DAGMIT GISHEN MARYAM ETHIOPIAN ORTHODOX CHURCH

2 NEW ADDITION MINOR AMENDMENT 3-28-19

SITE PLAN

Sheet Number: **C-1**

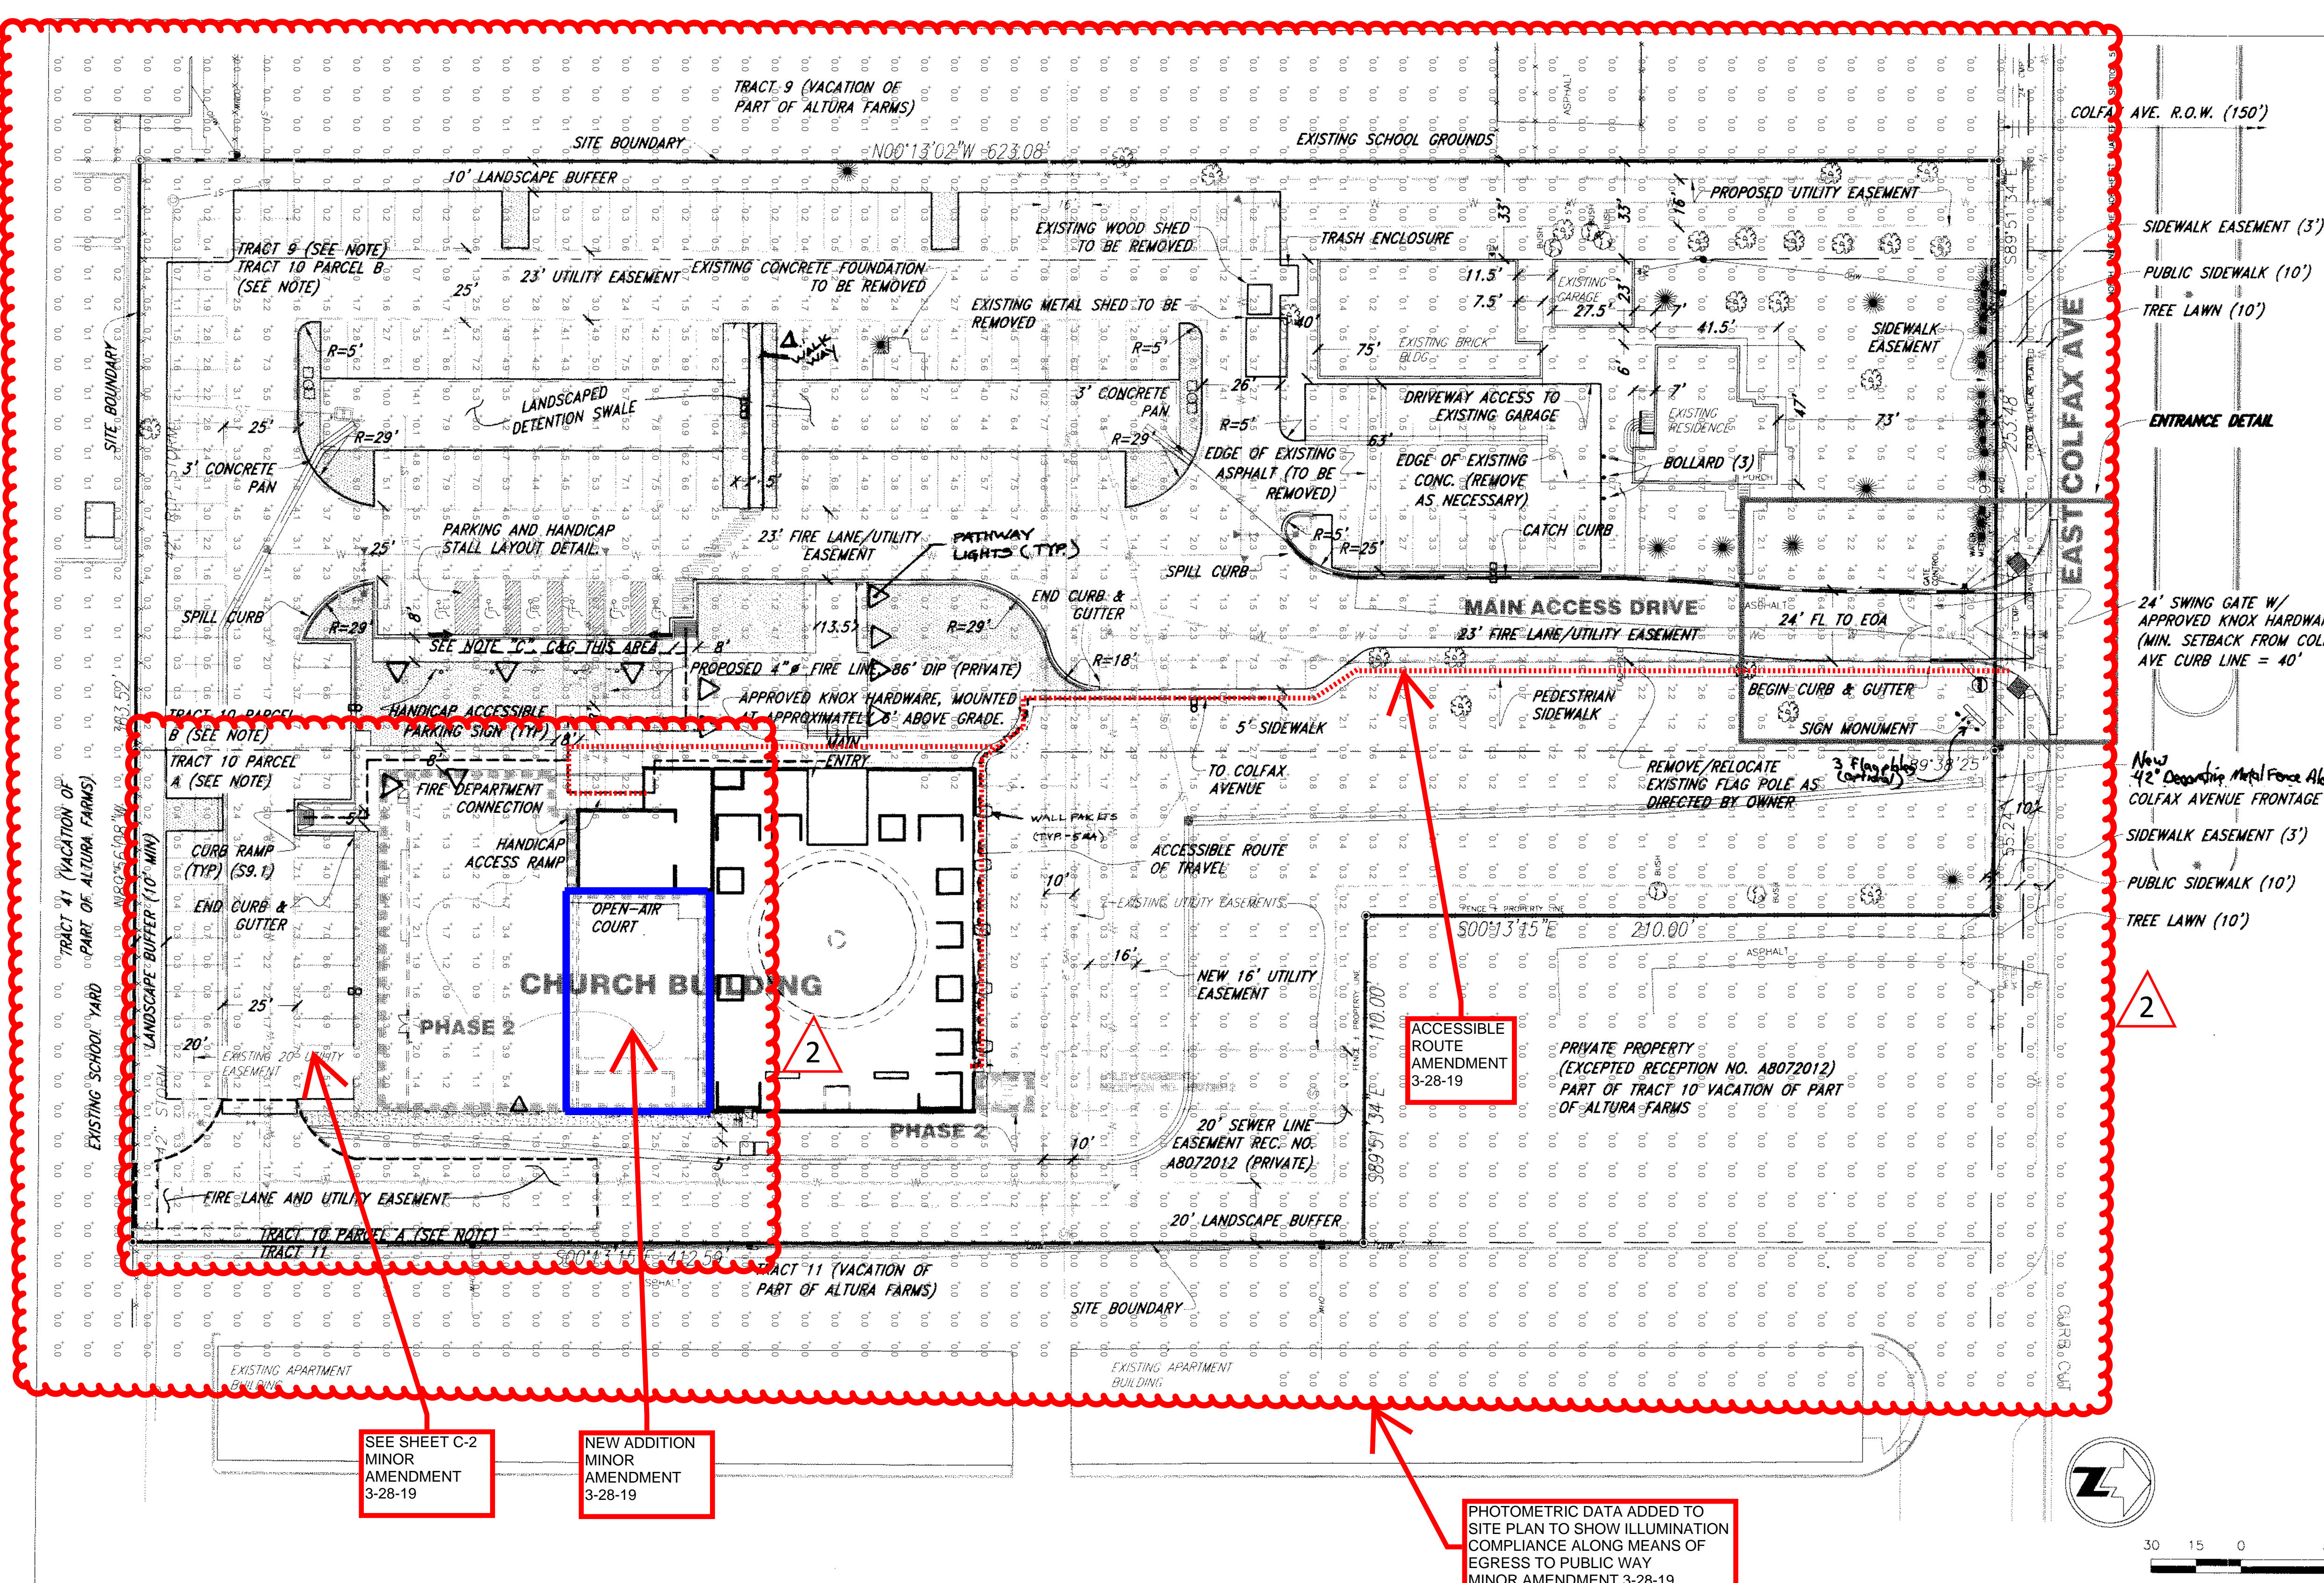
Reach out to CDOT to determine if this change requires a new access permit. Colfax Ave is a state highway. This is an extension of an existing use, reach out to CDOT to have them determine if a new access permit is required. Approval and access permits will need to be obtained from the Colorado Department of Transportation (CDOT). Please contact Marilyn Cross at CDOT, phone number 303.512.4266. In order to insure CDOT will allow access as shown, provide a letter from CDOT indicating they have reviewed the proposed access(es) and have given preliminary approval.

Land area within property lines:	Revise to include new addition.	4.7 Acres
Gross floor area:		18,000 Sq. Ft.
Number of buildings:		1
Maximum height of buildings:		25' Occupied
Total building coverage:		8.7% and 18,000 Sq. Ft.
Hard surface area:		52% and 105,748 Sq. Ft.
Landscape area:		48% and 100,121 Sq. Ft.
Present zoning classification:		R-A
Permitted maximum sign area:	Validate that new addition will be the same height to different.	116 Sq. Ft.
Proposed total sign area:		102 Sq. Ft. (Entry=45 sf; Bldg=57 sf)
Proposed Number of signs:		2 (1 at Entry; 1 on Building))
Parking spaces required:		160 (Place of Worship: 1 space per 4 seats)
Parking spaces provided:		165
Handicap spaces required:		6
Handicap spaces provided:		6
Loading spaces required:		0
Loading spaces provided:		0
Building Construction Type:		V-A, Fully-sprinklered

PHOTOMETRIC DATA ADDED TO SITE PLAN TO SHOW ILLUMINATION COMPLIANCE ALONG MEANS OF EGRESS TO PUBLIC WAY
MINOR AMENDMENT 3-28-19

Landscape Plan

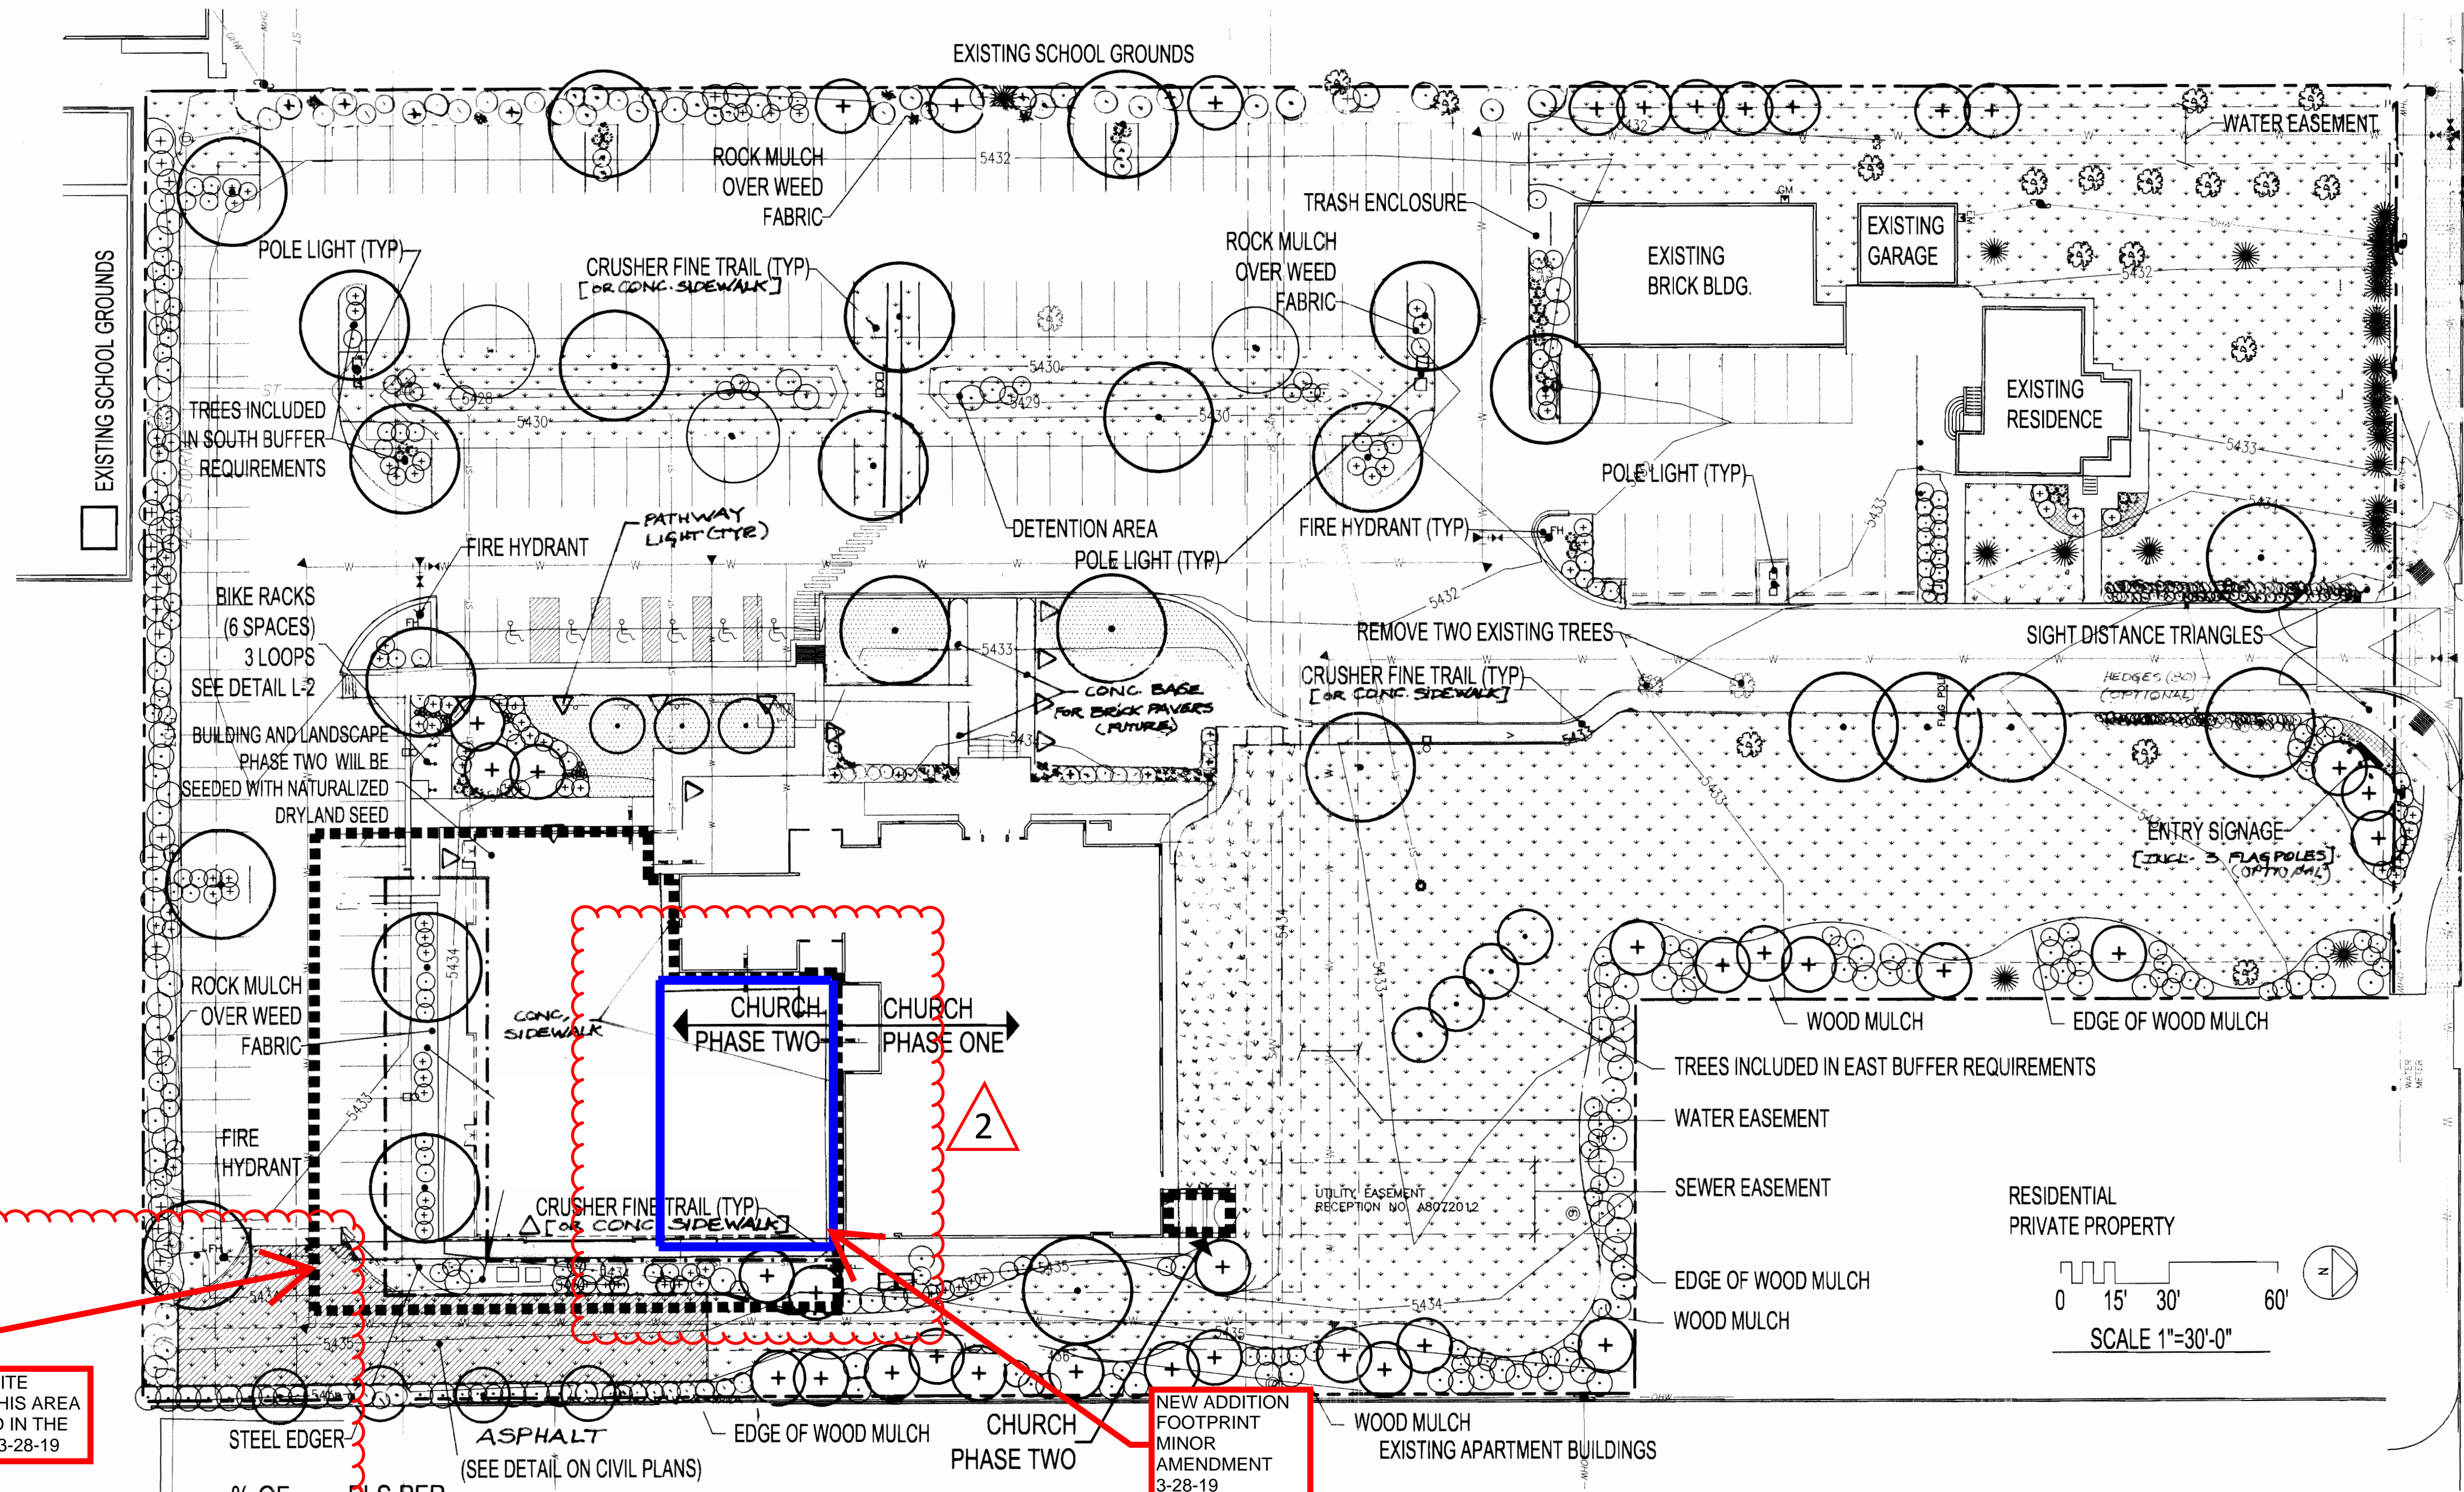
NO ASH TREES
WILL PLANTED
MINOR
AMENDMENT
3-28-19
